Product Change Notice (PCN)

PCN Number: PCN-0451205R-01

Product(s) Affected: PJ-057BH

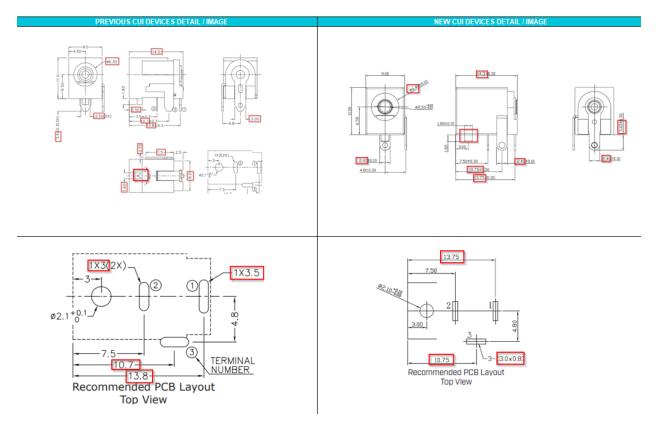
Description of Change: *Minor Housing and footprint differences. Material Change on the housing and terminals. See image Below*

MATERIAL	PLATING
center pin	copper	nickel
terminal 1	brass	silver
terminal 2	copper alloy	silver
terminal 3	brass	silver
plastic	PBT

DESCRIPTION	MATERIAL	PLATING/COLOR
center pin	brass	nickel
terminal 1	brass t=0.40	silver
terminal 2	bronze t=0.30	silver
terminal 3	brass t=0.40	silver
cover	PA10T (UL94V-0)	black
housing	PA10T (UL94V-0)	black
